FARRAGUT MUNICIPAL PLANNING COMMISSION

AGENDA

September 15, 2022

REPORT TO THE FARRAGUT MUNICIPAL PLANNING COMMISSION

TITLE:	SITE GRADING PLAN	DRAWN BY:	MAB	SHEET NO:	C4.1
LOCATION:	115 S WATT RD FARRAGUT, TENNESSEE 37934 CLT Map 151, Parcel Nos. 07903, 079, 080, 081	CHECKED BY:	MAB	FILE NAME:	2140 - C4.0
Owner:	WATT ROAD INVESTMENTS, LLC	JOB NUMBER	2140	ISSUE DATE:	05/18/2018

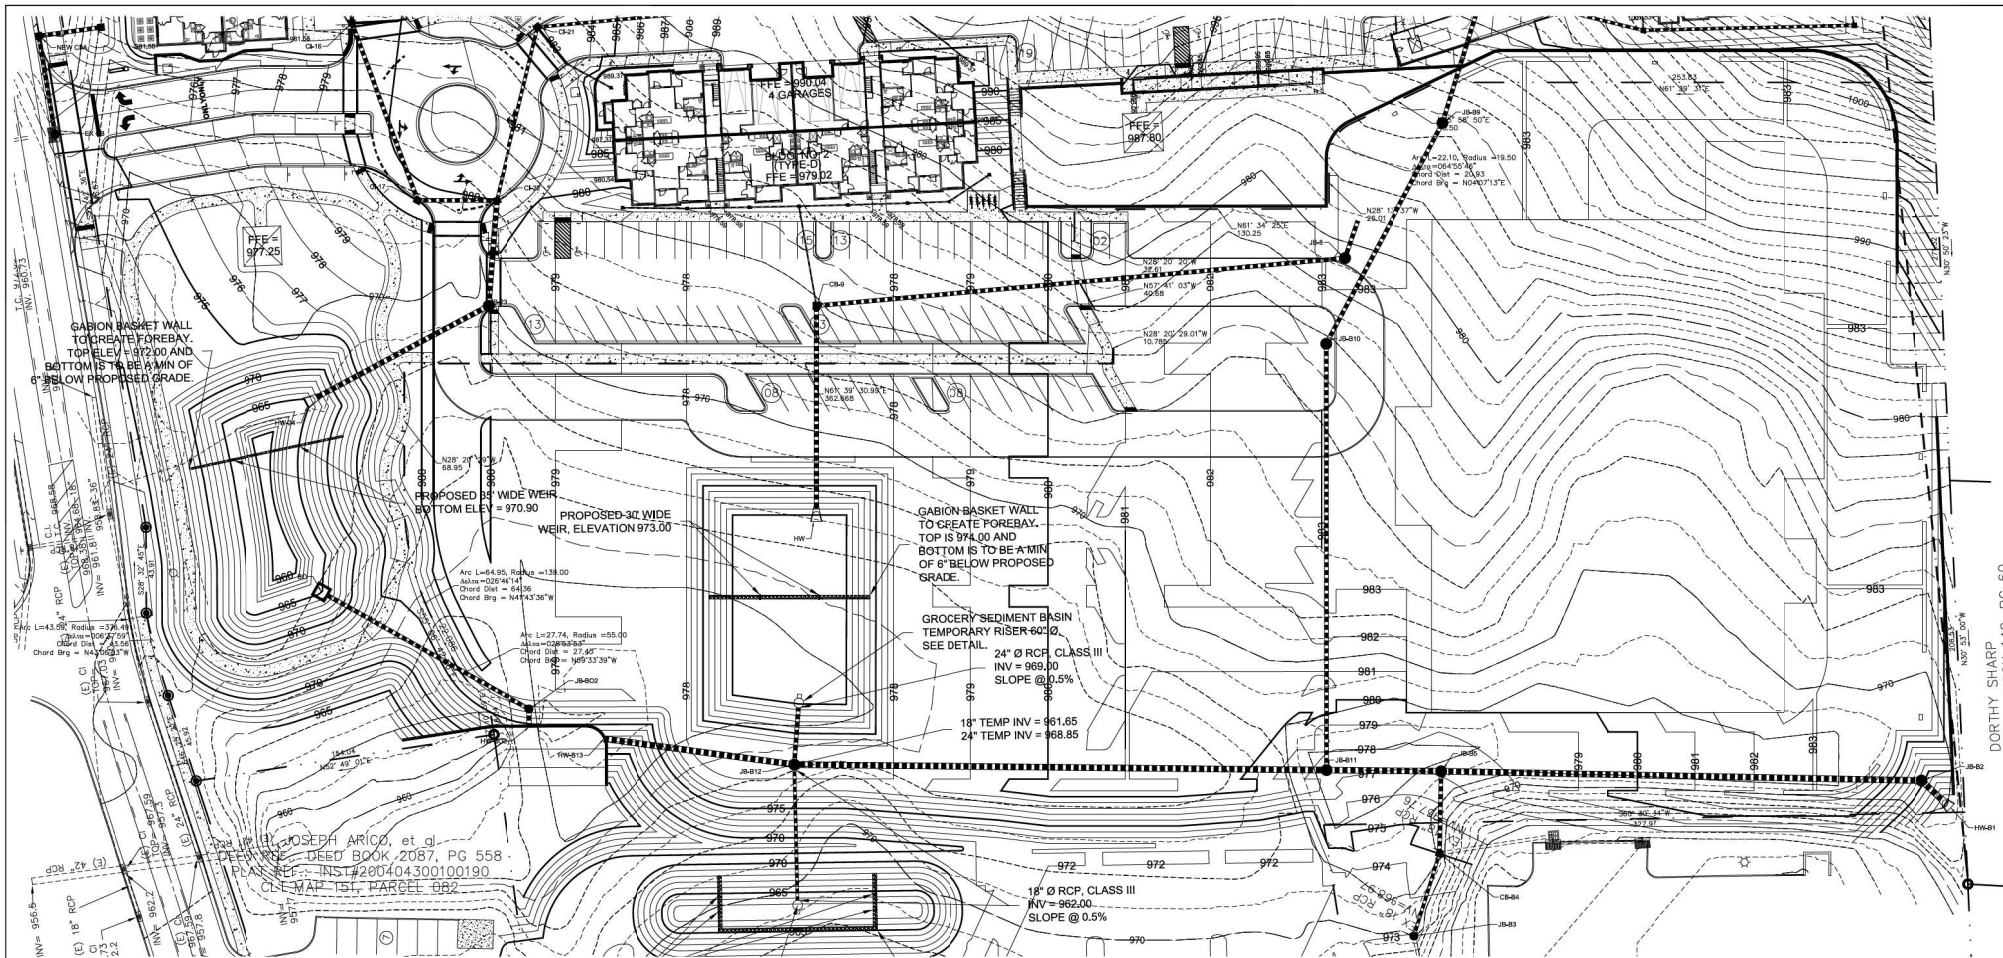
In terms of the removal of sections of retaining walls 17, 18, and 23, staff is open to this, but additional detail may be needed with the affected areas shown in an enlarged view. Staffs' understanding is that some of the elevations were incorrect on the original grading plan and now these areas that were shown with wall sections can be addressed through grading.

- Removed sections of retaining walls 17, 18, & 23.
- Revised grading per removal of wall sections noted above.
- Attached GBS Engineering sheets C4.1 & C4.2 for reference.

Plans have been revised to remove sections of retaining walls 17, 18, and 23, relocate and reduce the number of bicycle parking to current requirements, revise the curb and gutter to extruded curbs within the parking areas. We are leaving the retaining walls, compactor and grading of the open space area above the commercial area as currently approved.

Supplemental Drawing - Overall Site Plan
Kingston Pike Village
13106, 13110, 13120, 13140 Kingston Pike
Farragut, Tennessee 37934
CLT Map 151, Parcel Nos. 081

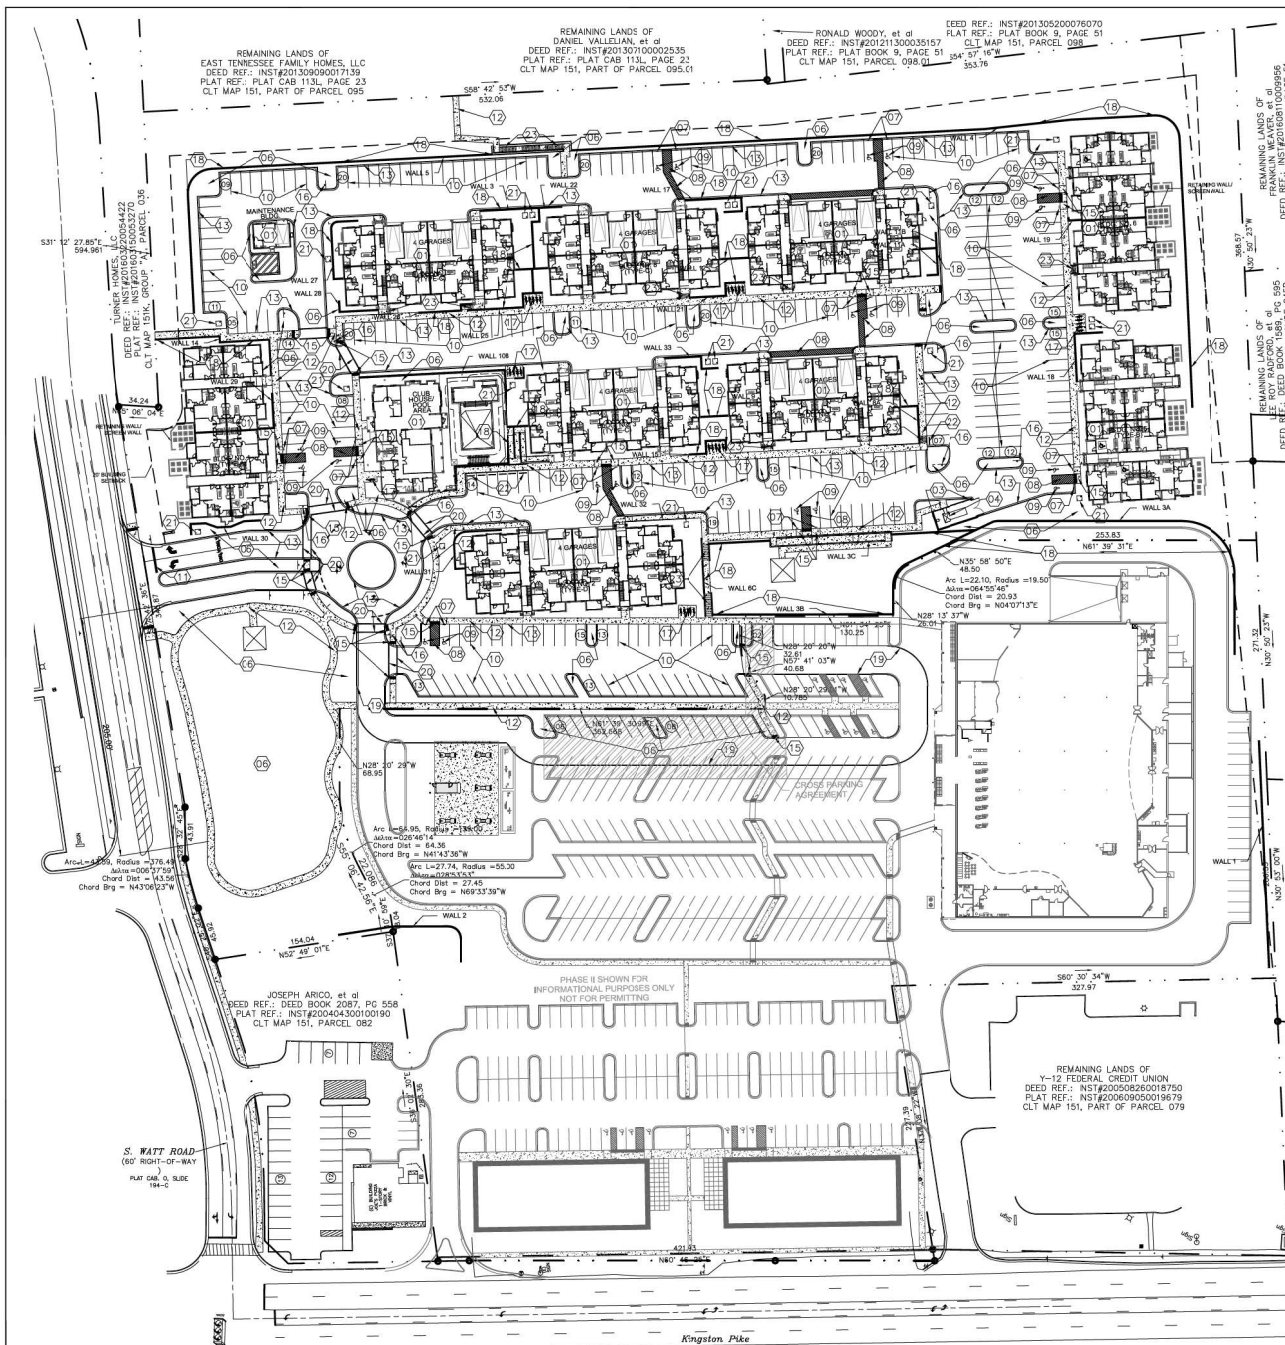
DISCUSSION AND RECOMMENDATION: Regarding these amendments, curb and gutter is generally a more aesthetically pleasing application than extruded curb that ties into the asphalt driving surface without a concrete gutter. Curb and gutter also accommodates drainage somewhat more effectively than extruded curb. Extruded curb, however, is permitted and exists in many locations throughout Town. The curbing internal to this project will be privately maintained so the lack of curb and gutter is less of a concern from staffs' perspective.

In terms of the bicycle parking provisions, staff supports the proposed change. Currently there are 62 bicycle parking spaces provided. The reduction to 20 spaces that are distributed throughout the development and that would comply with current requirements would create consistency moving forward. It is also likely that bicycles owned by residents will be stored within their apartment unit.

- Relocated bike racks and reduced total quantity.
- Revised curb and gutters within parking areas to extruded curb.
- Revised sidewalk near roundabout per approved Phase II configuration of detention basin.
- Added bike rack detail.
- Added extruded curb detail.
- Added table showing total number of bike parking required.
- Added GBS Engineering sheet C3.0 for reference.

C3.1

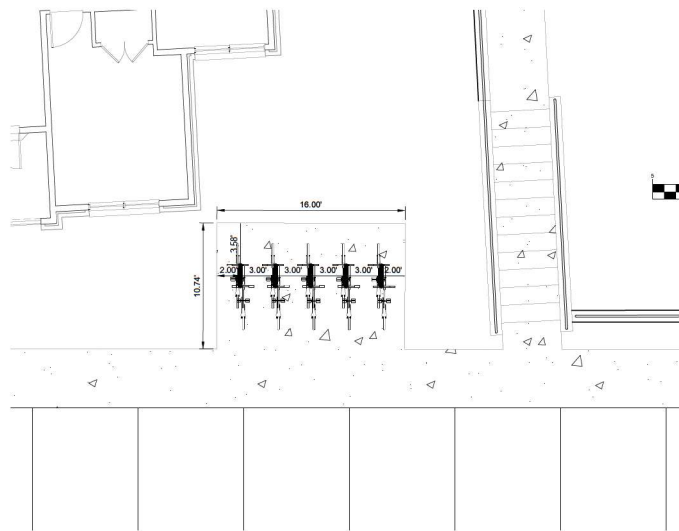
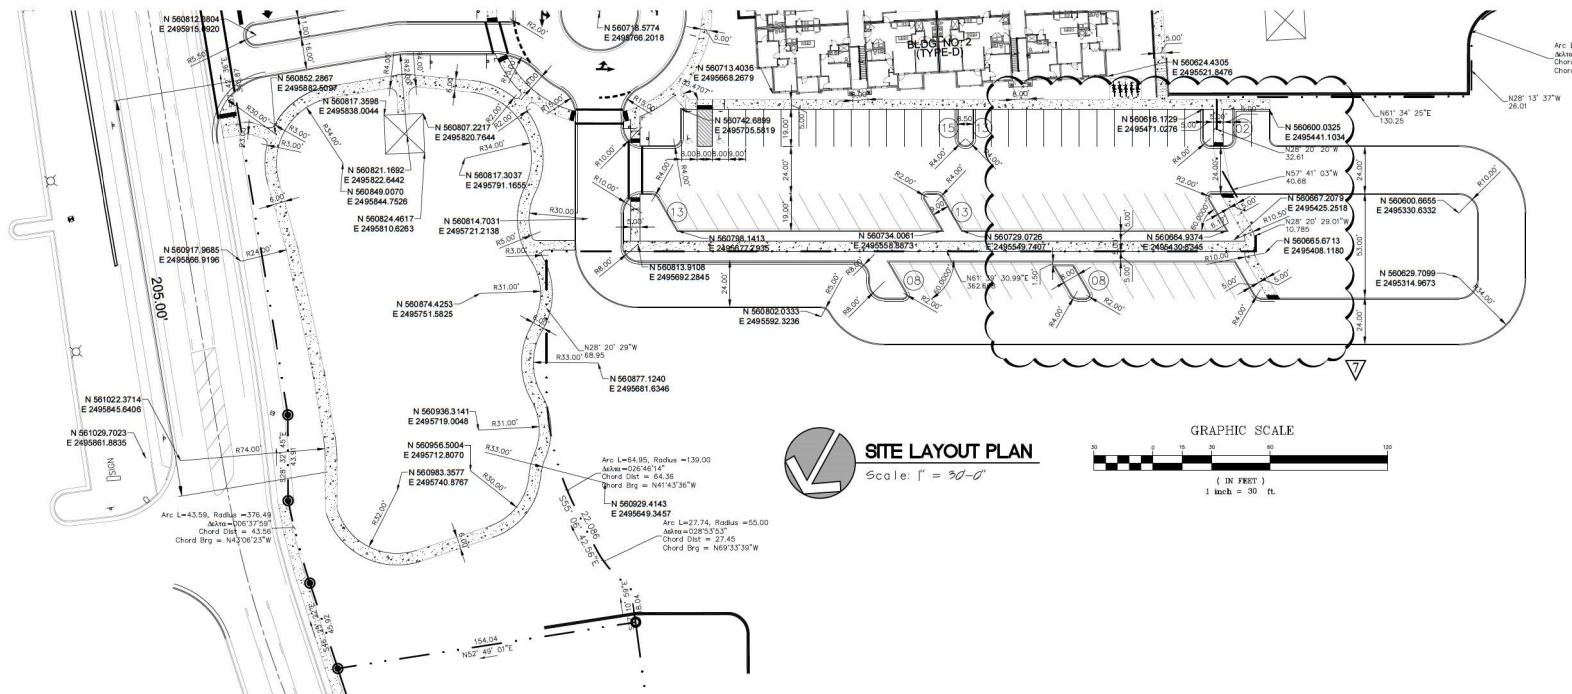
- Relocated bike racks and reduced total quantity.
- Revised curb and gutters within parking areas to extruded curb.
- Revised sidewalk near roundabout per approved Phase II configuration of detention basin.
- Added GBS Engineering sheets C3.1, & C3.2 for reference.
